Wisconsin Department of Transportation

Proposal #40: 8110-02-73

Loop Trail System (Ped/Bike Facility)

This is Addendum No. 01, which provides for the following:

SHEET 38A

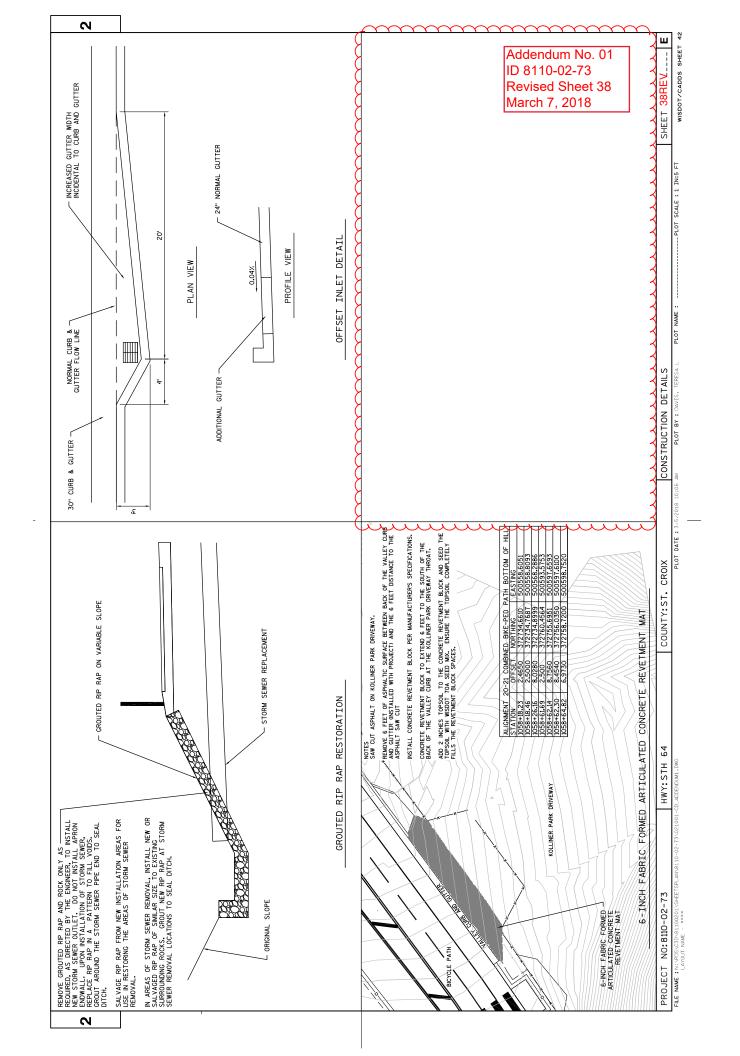
Added Plan Sheets
Plan	Plan Sheet Title (brief description of why sheet was added)
Sheet	Plan Sheet Title (brief description of why sheet was added)
38A	Construction Detail (Added in revised Interpretive Post and Base detail)
582A- 582F	Cross Sections: Hawk Street North Sidewalk

PRE-DRILL HOLES (TYP); SIZE OF HOLES TO BE COORDINATED WITH INTERPETIVE PANEL MANUFATURER TO ALLOW FOR BLIND MOUNTING OF INTERPRETIVE PANEL WITH INTERPRETIVE PANEL WITH WITHSPRETIVE PANEL WOUNTING HARDWARE - CONCRETE SIDEWALK PAD, 5'X5.5'. SEE TABLE FOR FURTHER DETAILS 18 INCHES MIN CLEARANCE FROM EXPANSION JOINT TO EDGE OF 7-INCH CONCRETE AREA OR 4-INCH CONCRETE SIDEWALK PAD BACKER PANEL (INTERPRETIVE PANEL PROVIDED BY OTHERS) POST INTERPRETIVE PANEL -CONCRETE BASE, REQUIRED INSTALL EXPANSION JOINT PRIOR TO POURING CONCRETE SIDEWALK PAD AROUND CONCRETE BASE DESIGN REMOVABLE ANCHORAGES (TYP) SURFACE PLATE MOUNTING HARDWARE

INTERPRETIVE PANEL DESIGN SHOULD INCLUDE MINIMUM 5/8" OVERLAP OF PANEL TO CONCEAL BACKER PANEL.

DESIGN BACKER PANEL THICKNESS TO HOLD INTERPRETIVE PANEL AS DESIGNED BY ST. CROIX COUNTY INTERPRETIVE PANEL MANUFACTURER.

BACKER PANEL TO BE ORIENTED 30° FROM HORIZONTAL.

POST LENGTH TO ALLOW FOR 30 INCHES MOUNTING HEIGHT FOR INTERPRETIVE PANEL.

WHERE PANEL WILL NOT BE PLACED IN CONCRETE SIDEWALK AREA, ADD 5' X.52, CONCRETE SIDEWALK 4-INCH PAD. LOCATE PAD AROUND INTERPRETIVE PANEL CONCRETE BASE PER ENGINEER. SEE TABLE FOR PURTHER DETAILS.

SURFACE MOUNTED PLATE AND ANCHORAGES TO BE DESIGNED TO ALLOW THE INTERNETIVE PANEL SELF-SUPPORTING POST SYSTEM TO BE REMOVAREL.

ENSURE 18 INCHES CLEARANCE FROM CONCRETE BASE EXPANSION JOINT TO BACK EDGE OF 4-INCH CONCRETE SIDEWALK PAD OR 7-INCH CONCRETE SIDEWALK AREA.

ANCHORAGES TO BE REMOVABLE AND REPLACEABLE MULTIPLE TIMES WITHOUT DAMAGE TO THE CONCRETE BASE.

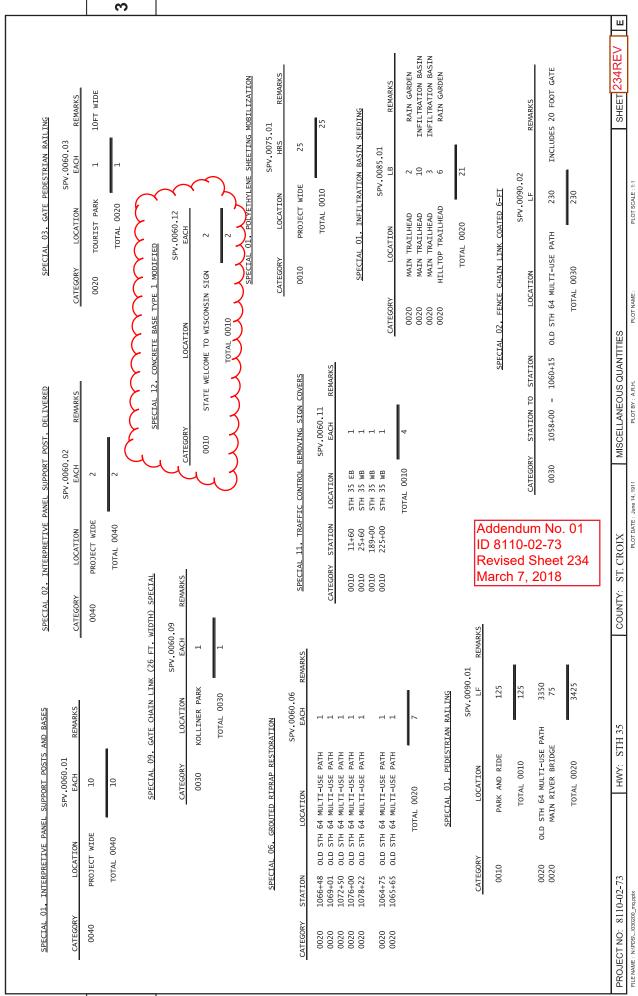
Revised Plan Sheets
Plan Sheet	Plan Sheet Title (brief description of changes to sheet)
4	Existing Typical Sections – Main St (Added existing pavement depths)
5	Existing Typical Sections – State St, Rainbow St, CTH E (Added existing pavement depths)
6	Existing Typical Sections – Hilltop Dr., School Circle, Old 64 (Added existing pavement depths)
23	Finished Typical Sections-Trailhead Side Paths (Revised Hawk Street Sidewalk Section)
38	Construction Details (Deleted the Interpretive Panel construction detail from plan sheet)
80	Plan and Cross Section: Welcome to Wisconsin Sign (added in language for concrete bases for future lighting)
130	Permanent Signing: Main Street (Revised sign locations)
131	Permanent Signing: Main Street (Revised sign locations)
132	Permanent Signing: Main Street (Revised sign locations)
133	Permanent Signing: Main Street (Revised sign locations)
210	Miscellaneous Quantities (Revised Concrete Sidewalk 4-Inch)

211	Miscellaneous Quantities (Revised Storm Sewer Pipe Reinforced Concrete Class III 18-Inch table and Storm Sewer Pipe Reinforced Concrete Class III 24-Inch)
212	Miscellaneous Quantities (Revised Inlets 2.5x3 and Inlets 4-ft Diameter)
221	Miscellaneous Quantities (Revised Signing Table)
222	Miscellaneous Quantities (Revised Signing Quantities)
225	Miscellaneous Quantities (Revised Signing Quantities)
234	Miscellaneous Quantities (Added Concrete Base Type 1 Modified)
235	Miscellaneous Quantities (Revised Anti-Graffiti Coating)
357	State Welcome Sign Structure Sta 155+50 STH 64 EB (added language for concrete bases)
415	Earthwork (Added in table for Hawk Street Sidewalk)
